Main Drainage Channels for Ngau
Tam Mei, Yuen Long and Kam Tin:
Environmental Schedule

23 May 1996

Response to Comments
Main Drainage Channels for Ngau Tam Mei, Yuen Long and Kam Tin, EIA Study - Draft Final Environmental Schedule

FIGURE 5.1f - PROPOSED WATER QUALITY MONITORING LOCATIONS
FOR MAI PO LO WAI/SAN TSUEN (30CD OF VFPW)

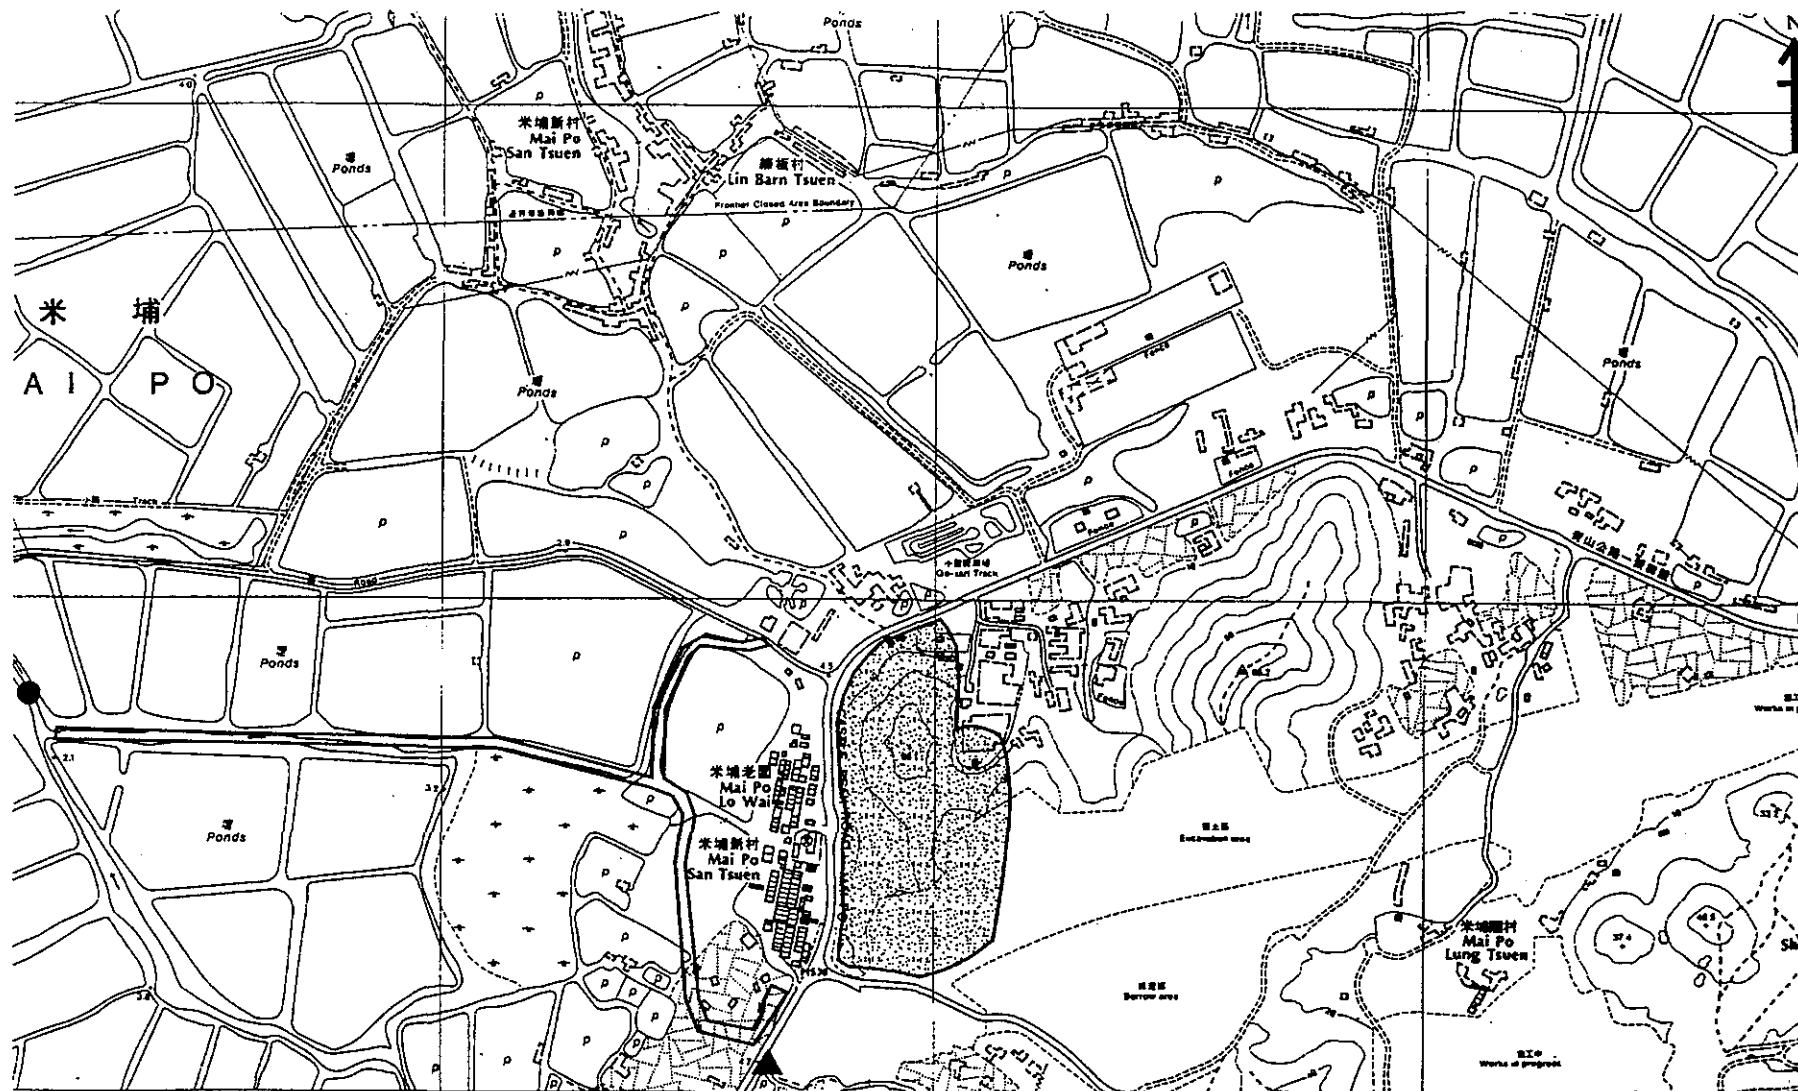
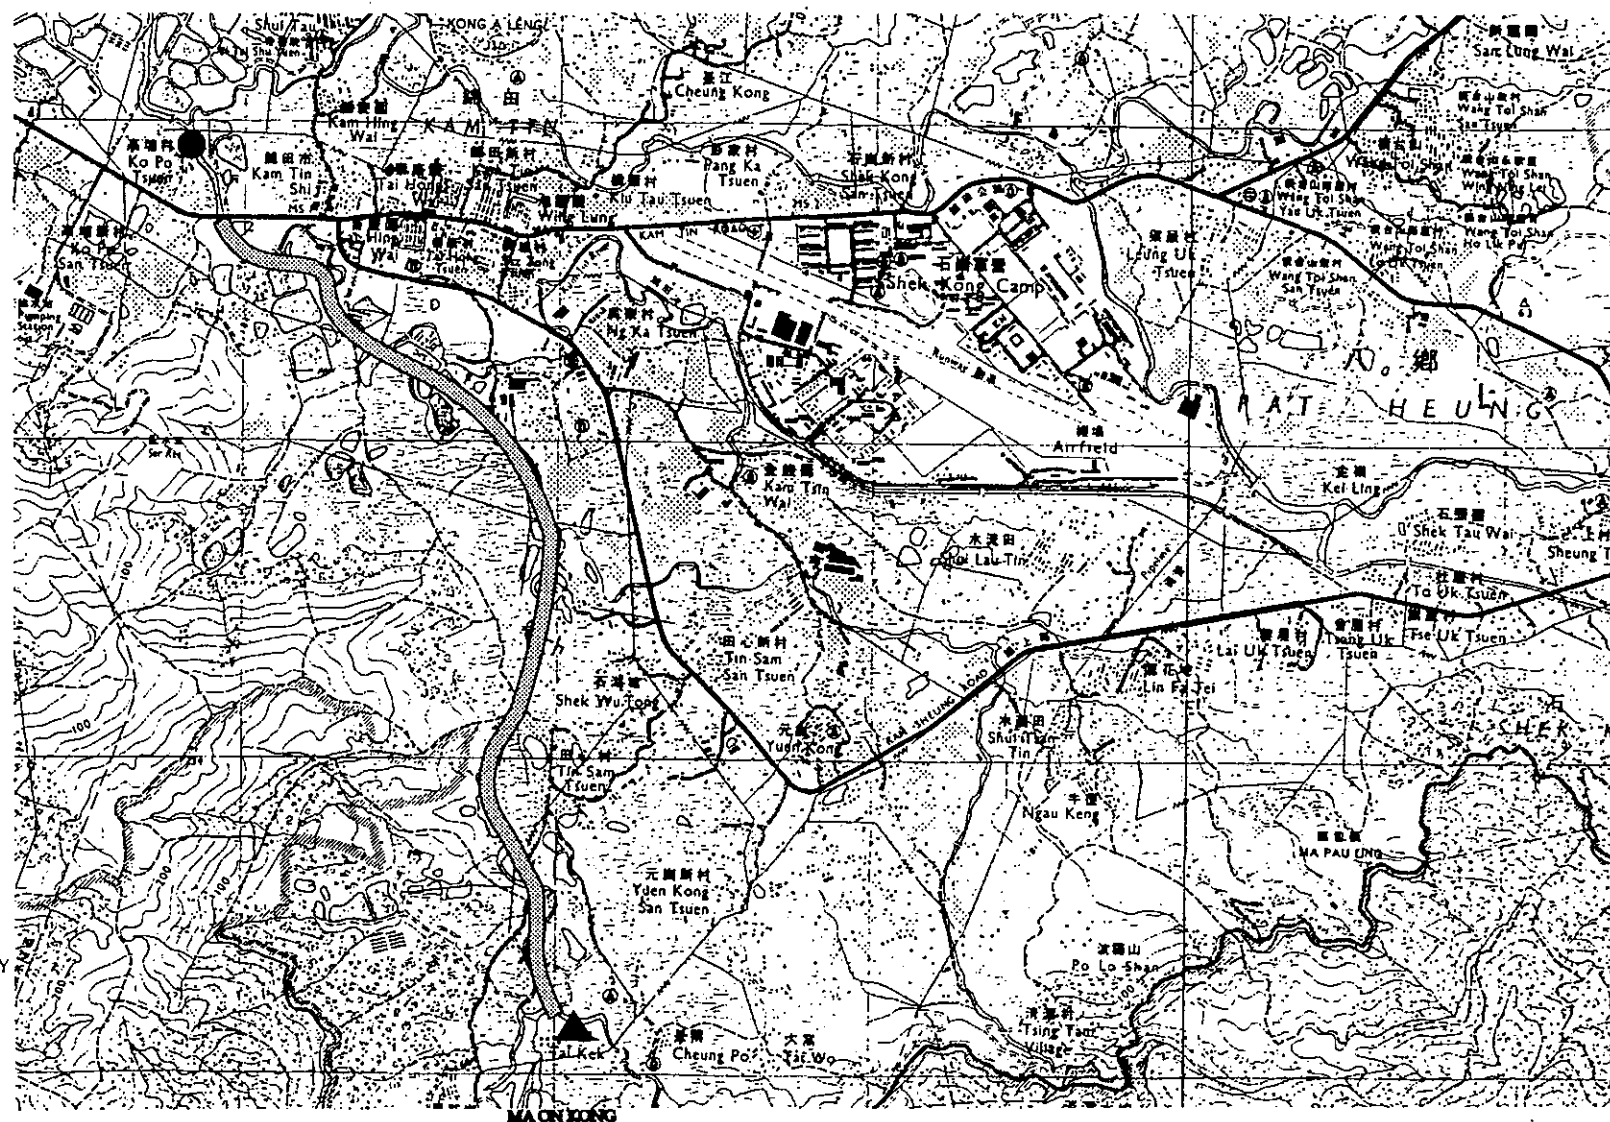
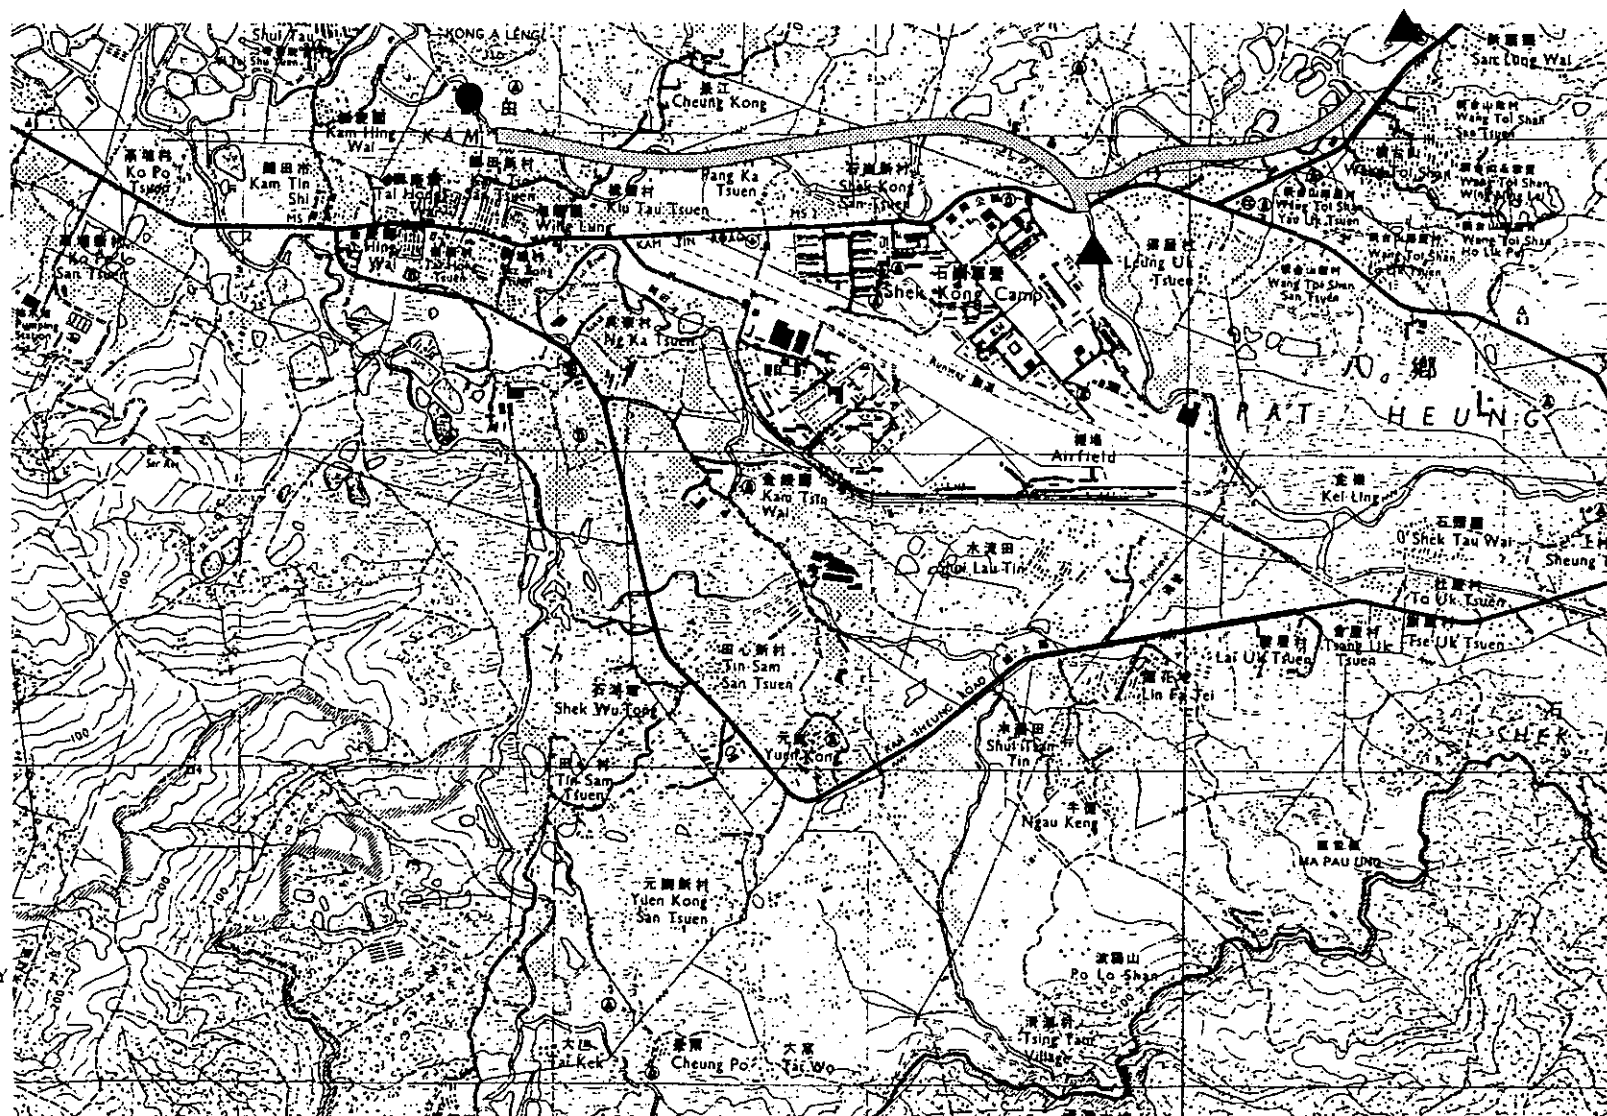
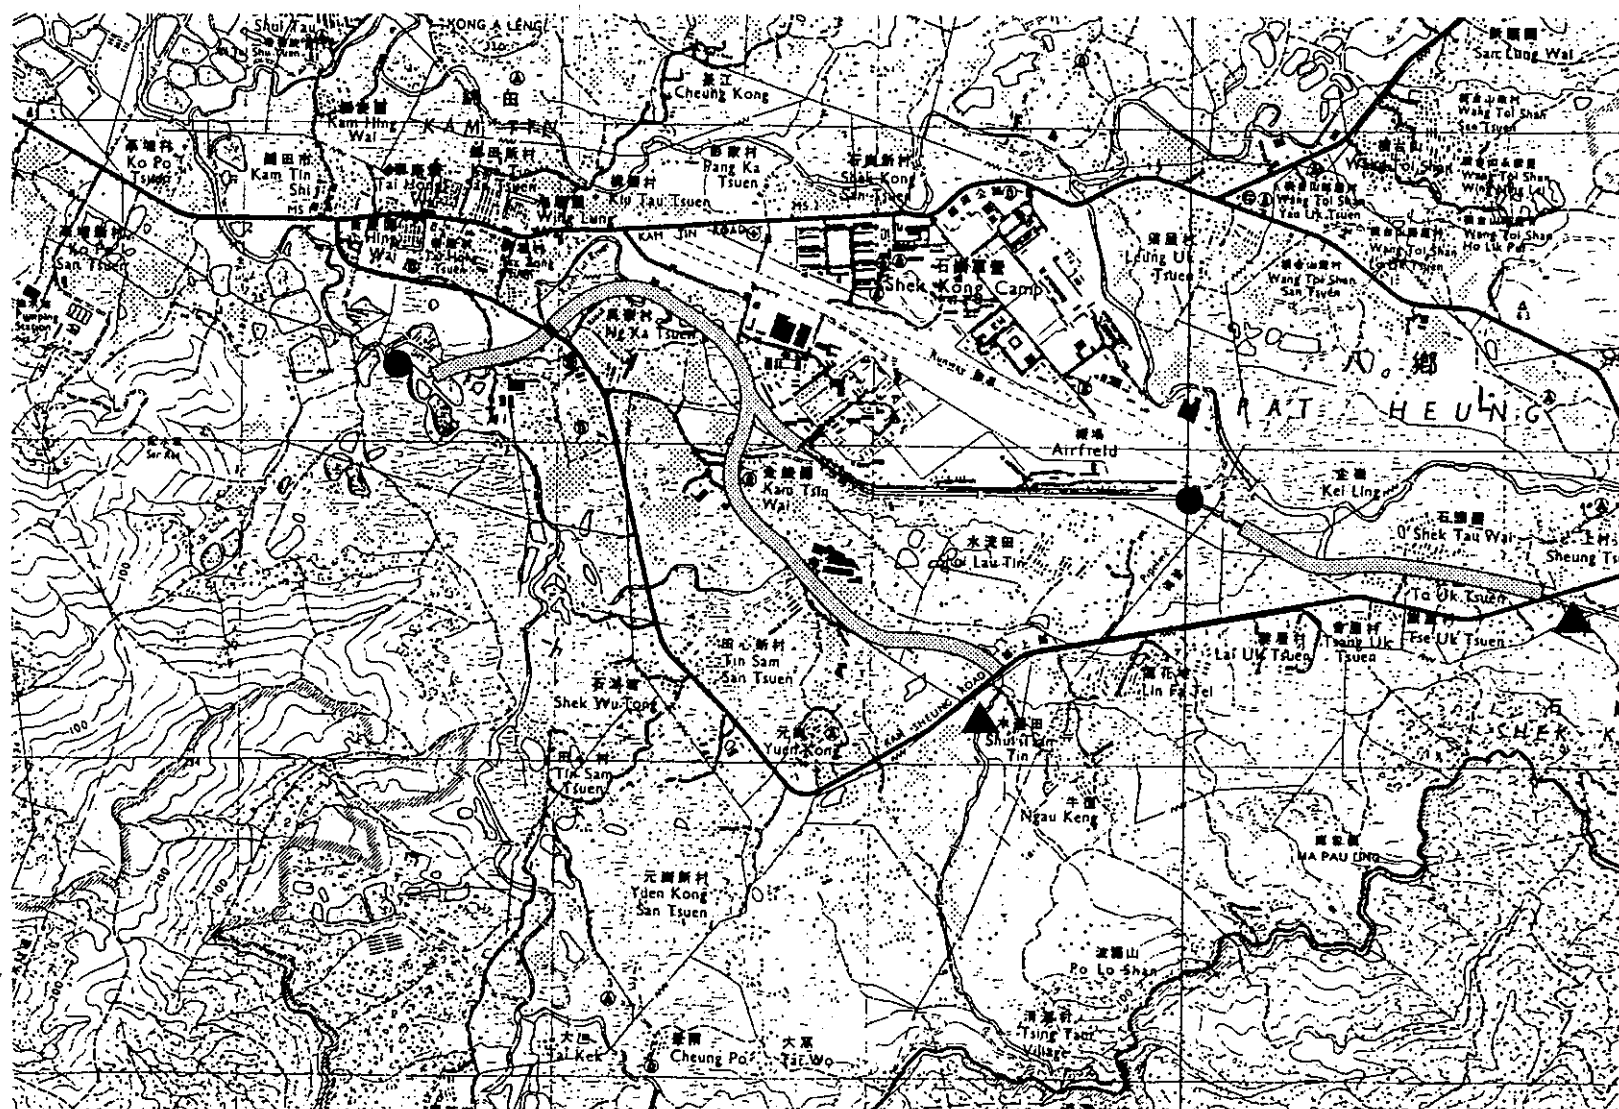
16.			ii) Figures 5.1a to 5.12k are not legible and should be further improved so that all the locations, grid co-ordination, existing rivers or streams and the construction areas can be well and clearly identified. Please make sure that all the monitoring and control stations are accessible and shown correctly in the drawings.	The clarify of all ES figures has been improved accordingly. See also response to comment 15 re: grid coordinates.
